PLANNING, ZONING, & BUILDING DEPARTMENT  
PZ&B Staff Combination Memorandum: Architectural Commission and Town Council

SUBJECT: ARC-24-065 (ZON-24-063) 137 E INLET DR

MEETING: MAY 29, 2024 ARCOM  
JUNE 12, 2024 TC

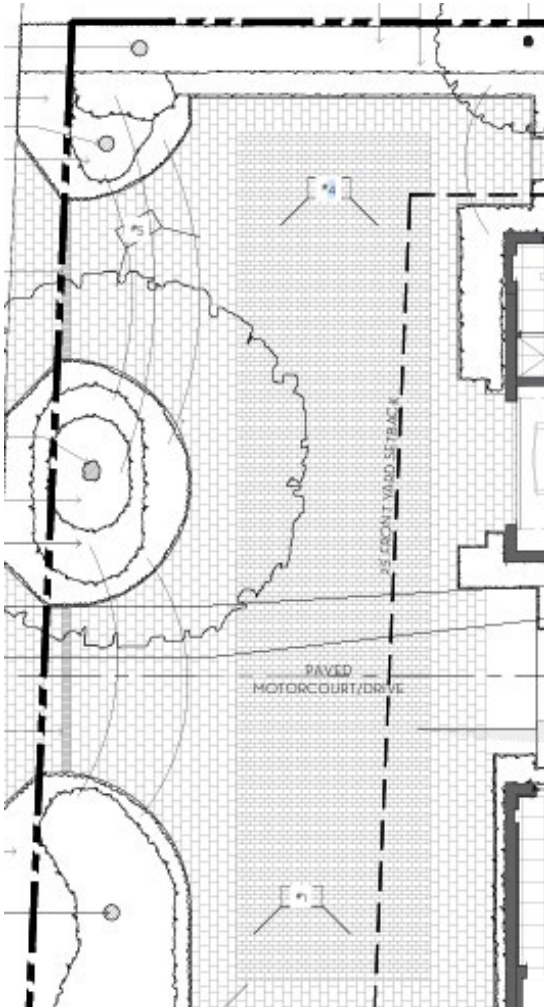
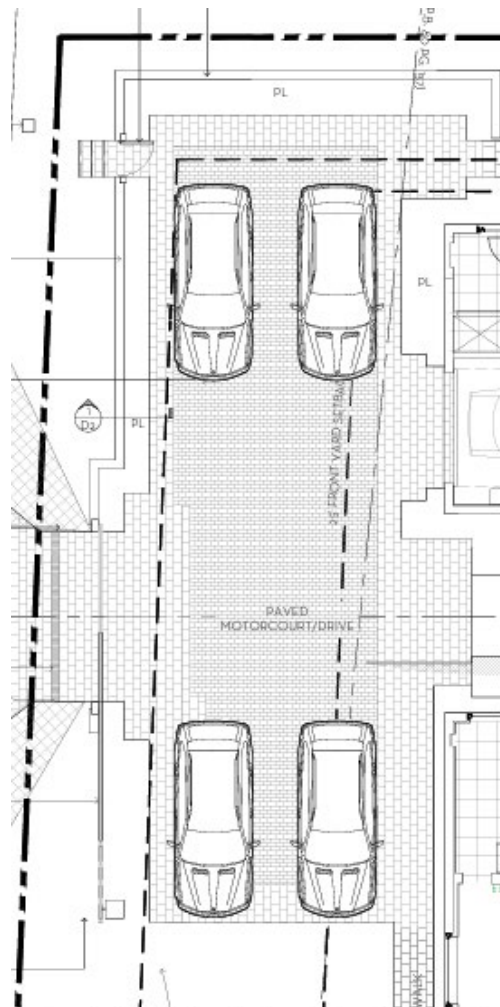
The applicant proposes to remove one of two curb cuts to create a single-entry driveway. New landscape and a wood pedestrian gate will be added in the area previously used as a driveway entrance increasing their open space calculations.

Matching in style and material commensurate with the style of house is a rolling vehicular gate which will be installed at 8'7" in lieu of the 18' required for vehicle queuing. The addition of the 4' high Ipe wood gate with matching gate will does alter the current transparency into the site.

### ***CURRENT CONDITIONS***

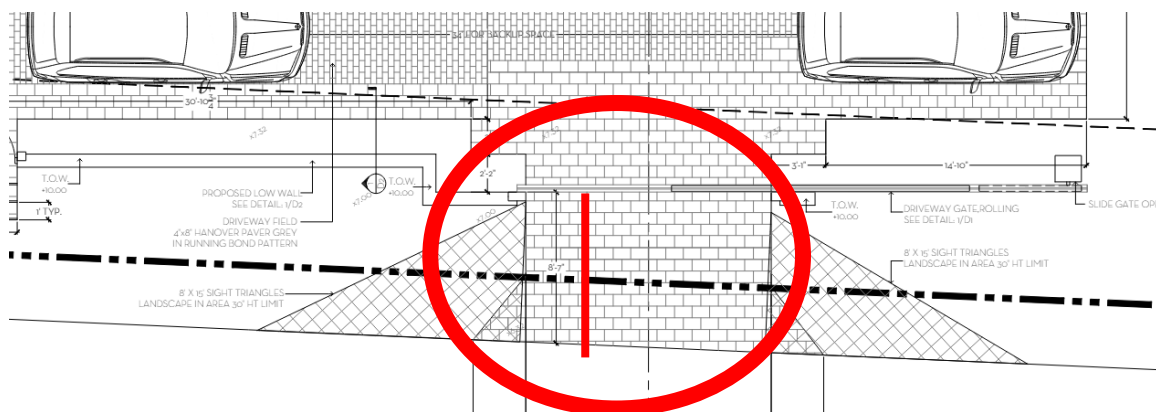
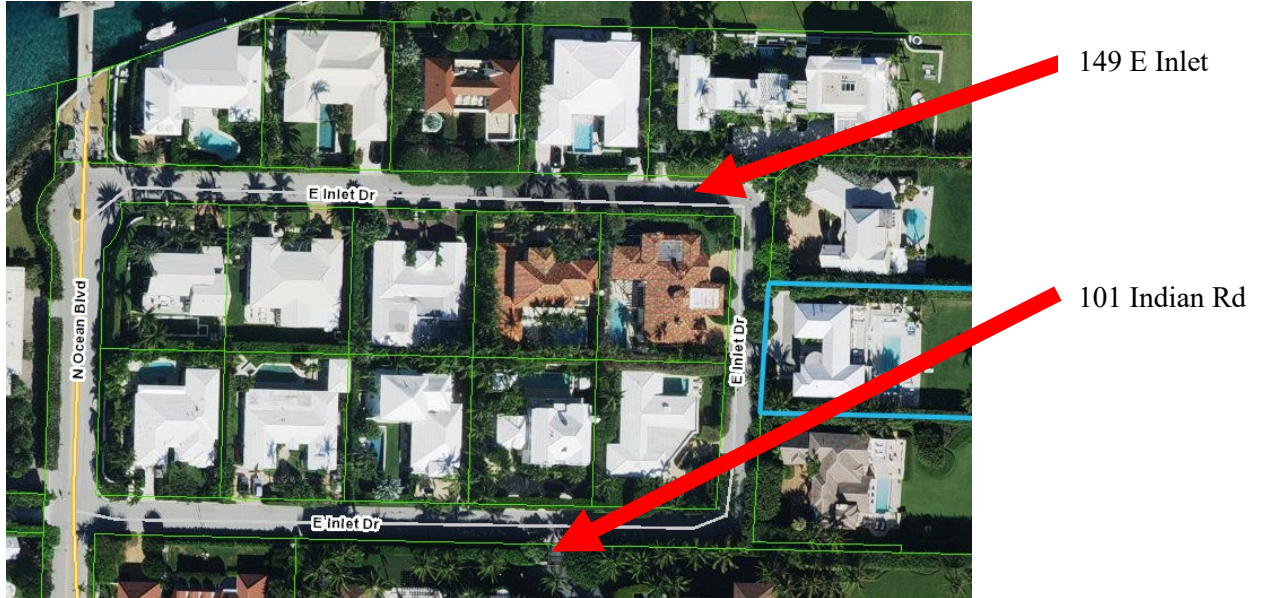
East Inlet Drive, located at the northernmost end of the Town and consists of 18 single family residences. Of the 18 residences there is only 1 site that has driveway gates as noted below which is also a solid gate with no transparency. A second vehicular gate is located on E Inlet as a secondary driveway to the property at 101 Indian Rd.

Based on the surrounding area, the introduction of the gate would be inconsistent with the majority of the other residences that are without gates and would obstruct the site-wide openness of the front yard.

Additionally, the proposed gate requires a variance as the required backup space is not being met, potentially creating an unsafe condition or blockage within the roadway. The applicant has provided 8'-7" of clearance where 18'-0" is needed.
